GENERAL PLAN AND ELEVATION
BR. 1 001 279

REHABILITATION OF BRIDGES
1 & 1A ON RISING SUN LANE
OVER BRANDYWINE CREEK

ADDENDUM NO. 2	B.K.B. II/05/08
MODIFIED NOTE

REHABILITATION PLAN AND ELEVATION

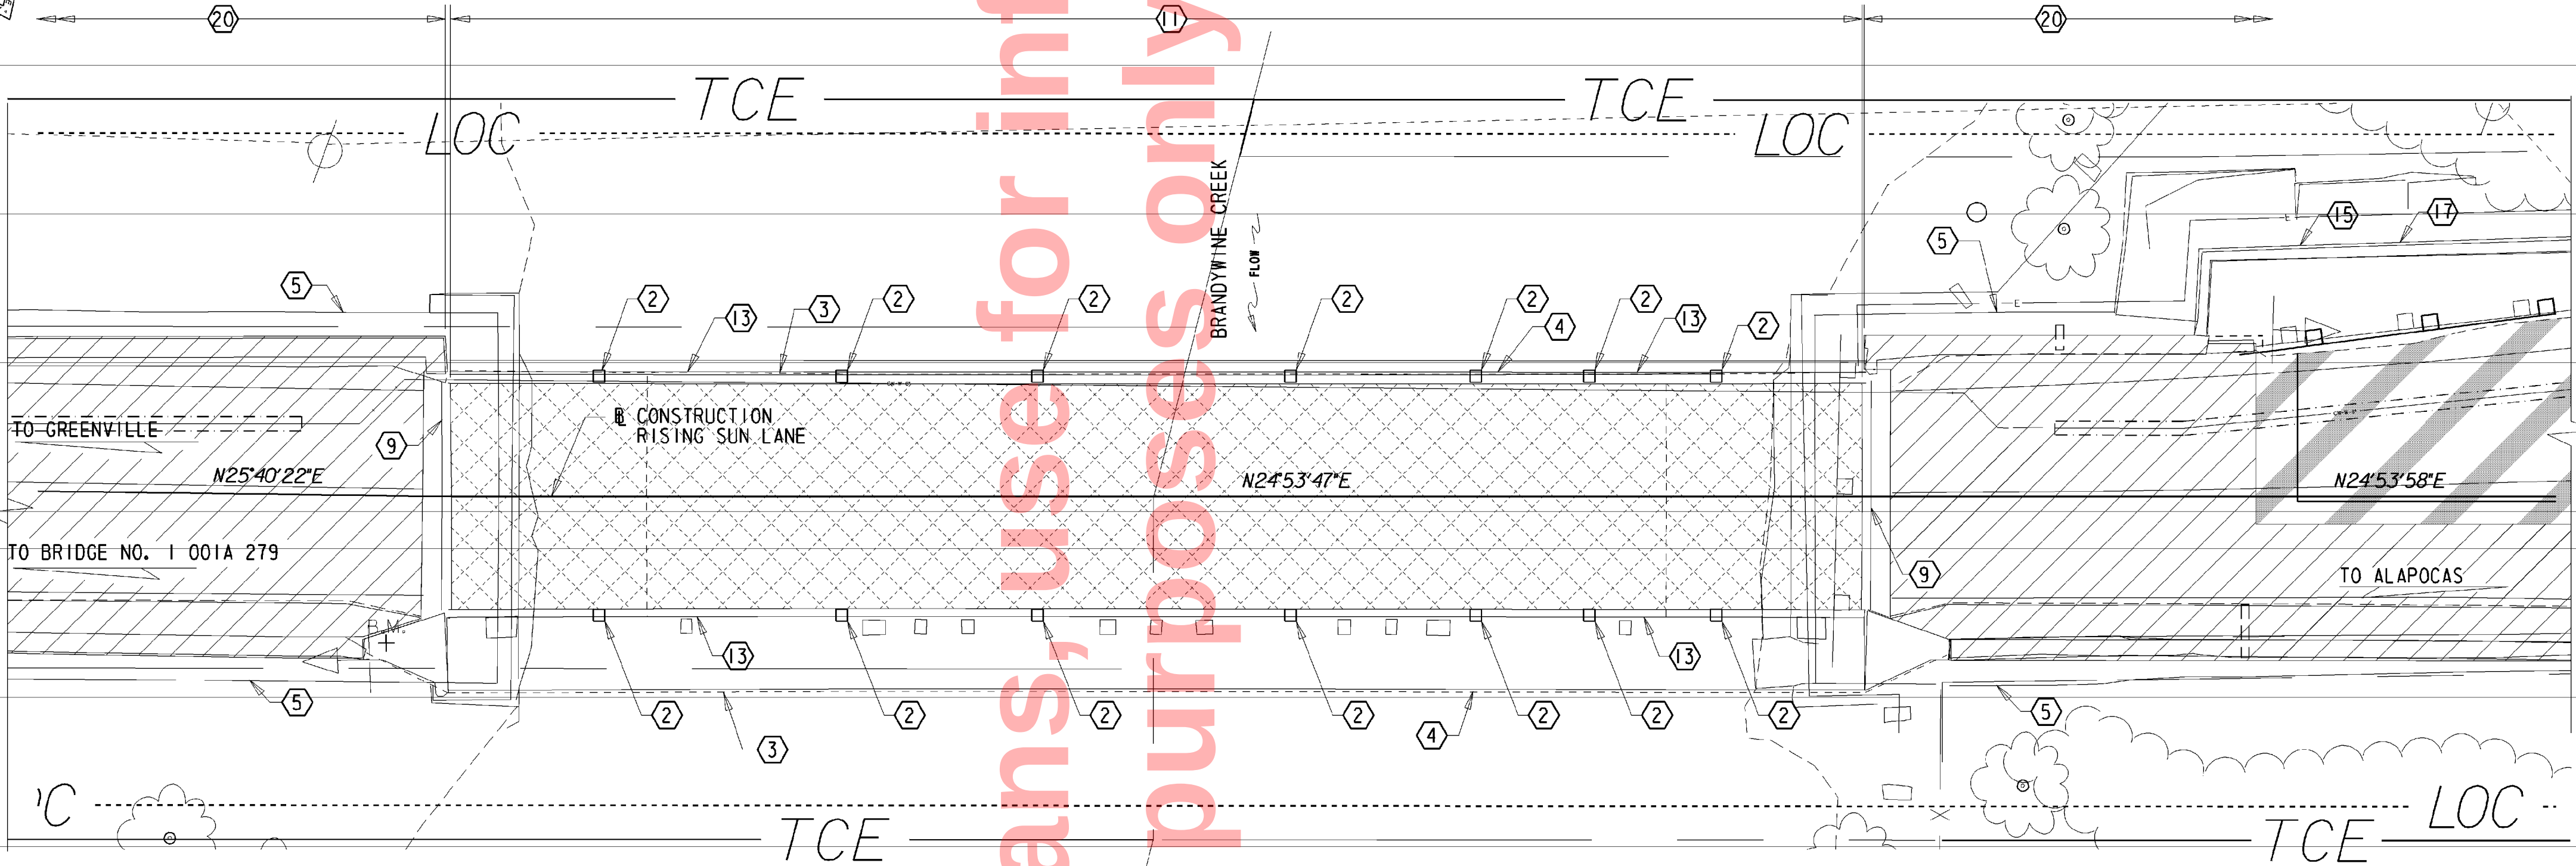
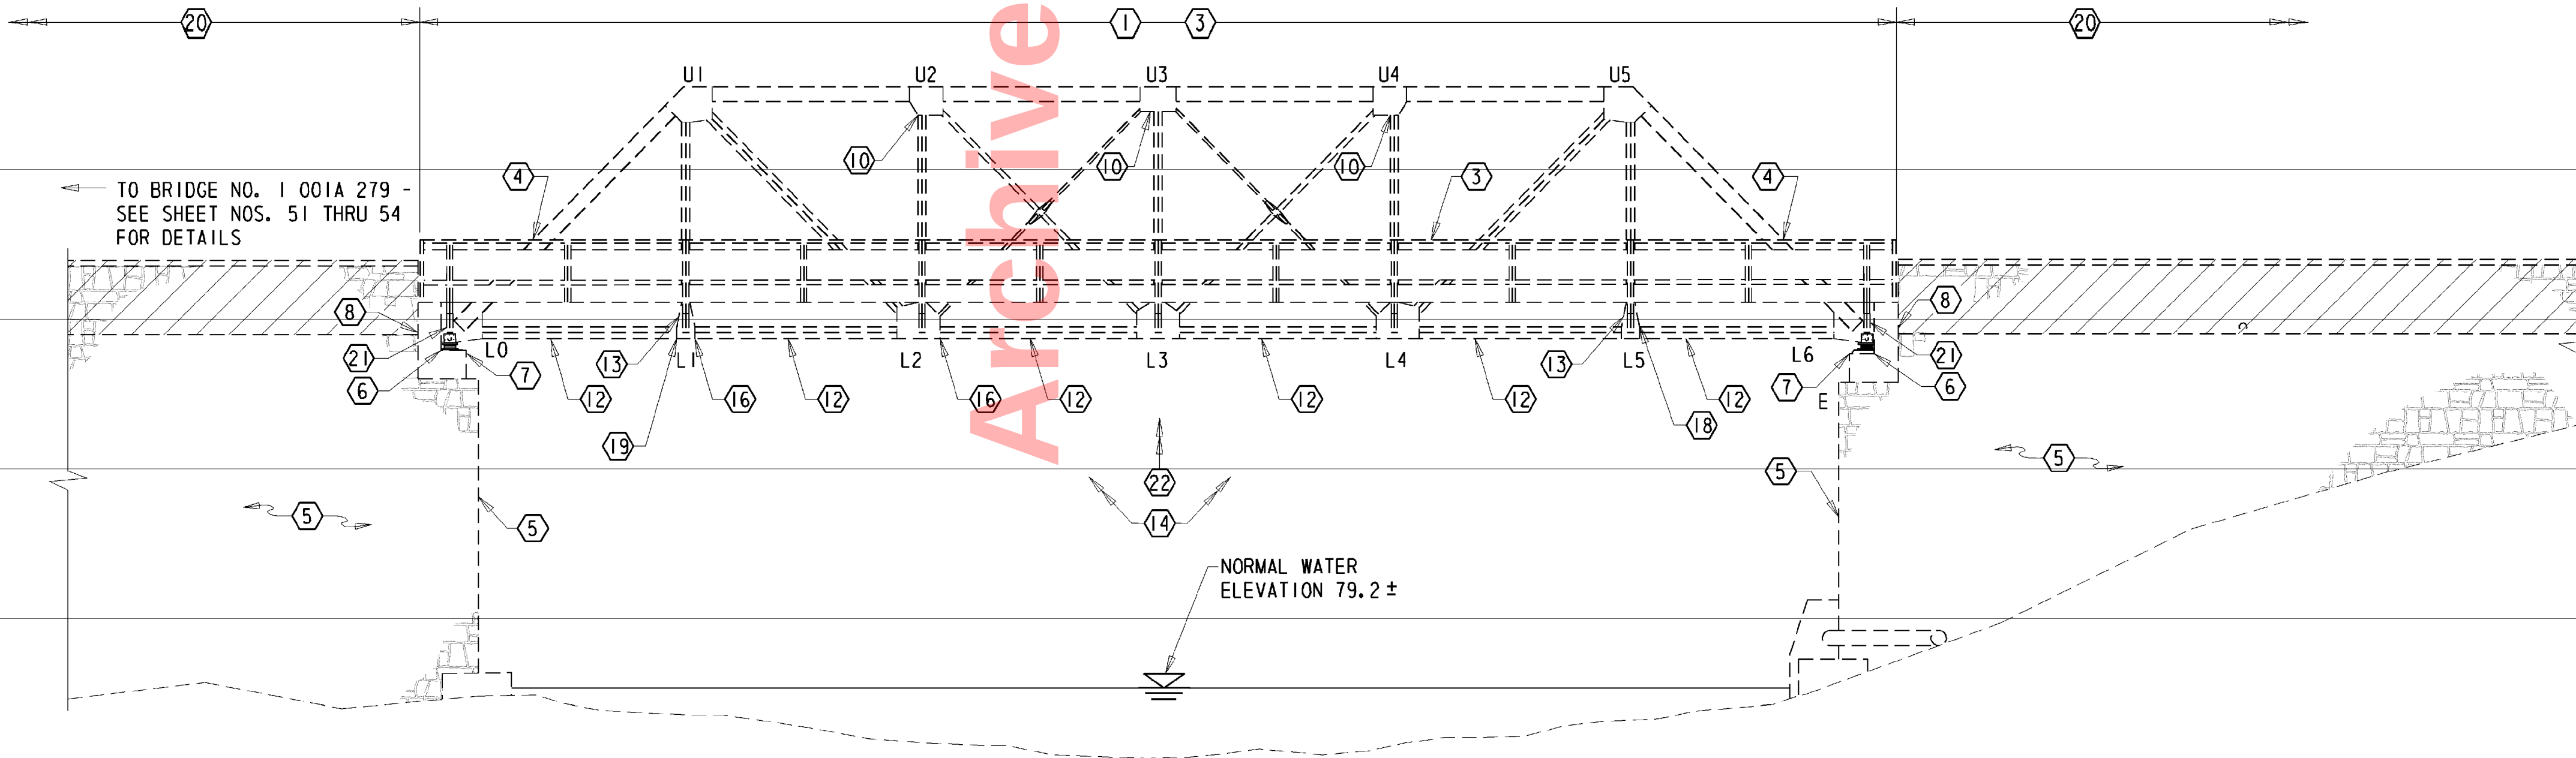
NEW SHEET	B.K.B. 11/05/08

- PLATE DIAPHRAGMS ABOVE BEARINGS. ITEM 605584 - STEEL STRUCTURE REPAIR. SEE SHEET NO. 40 FOR DETAILS.
- REPAIR CRACKED BOTTOM CHORD. ITEM 605584 - STEEL STRUCTURE REPAIR. SEE SHEET NO. 47 FOR DETAILS.

PROPOSED JACKING SCHEME ELEVATION
NORTH ABUTMENT

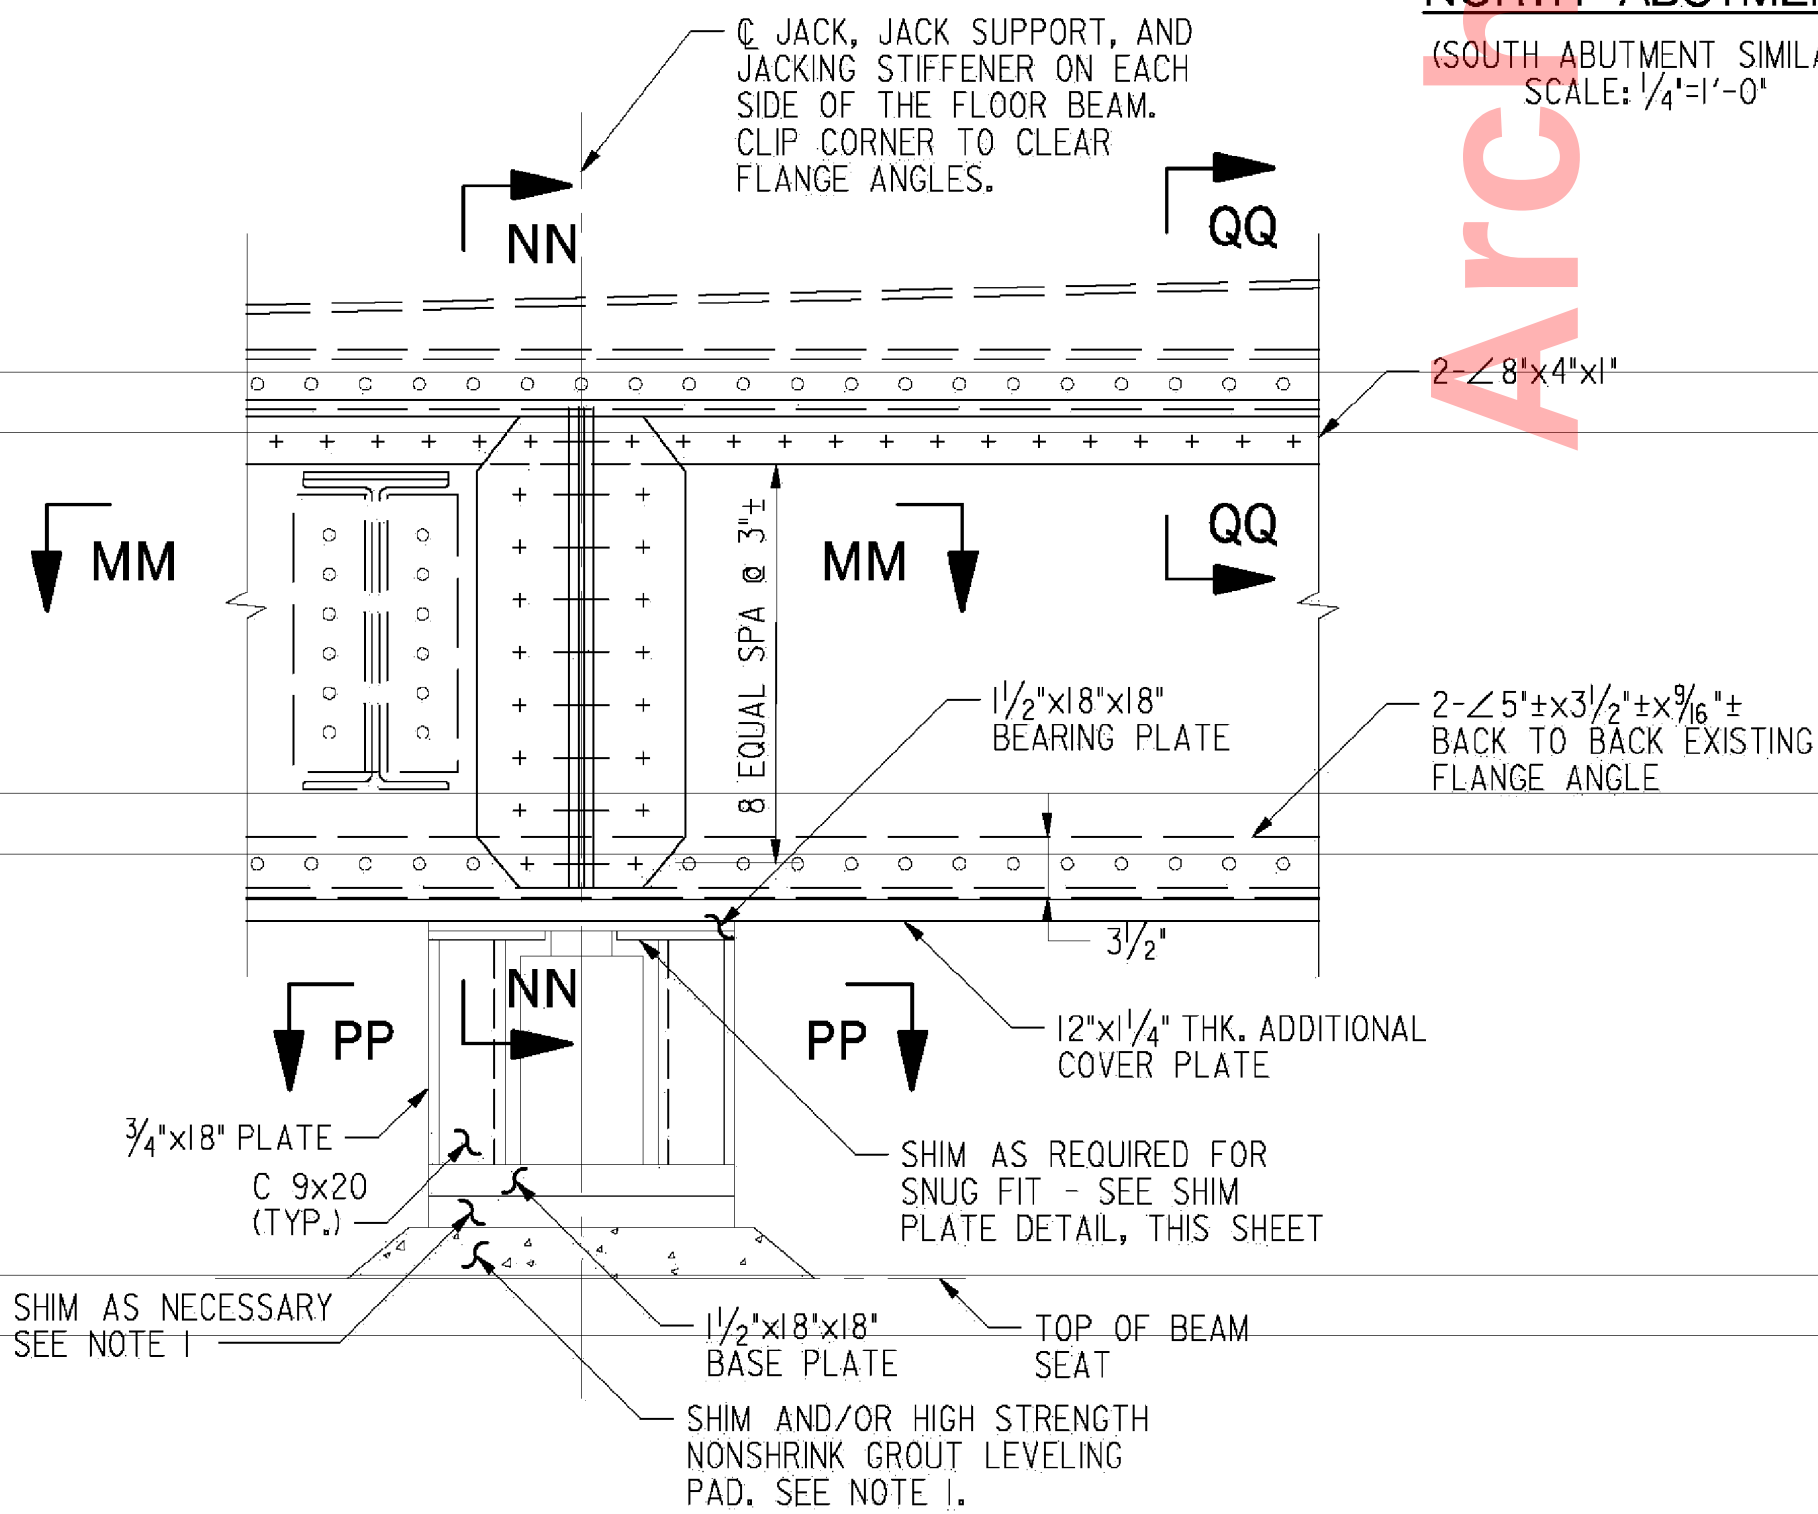
NEW SHEET	S.N. 11/05/08

- Q JACK, JACK SUPPORT AND THE JACKING STIFFENER ON EACH SIDE OF THE FLOOR BEAM SHALL BE LOCATED 4'-0" FROM THE Q OF THE TRUSS OR AT THE Q OF THE EXISTING RIVET, WHICHEVER CONTROLS, IN ORDER TO REPLACE THE EXISTING 3/4" RIVETS WITH PROPOSED 1/2" DIA. HIGH STRENGTH BOLTS.
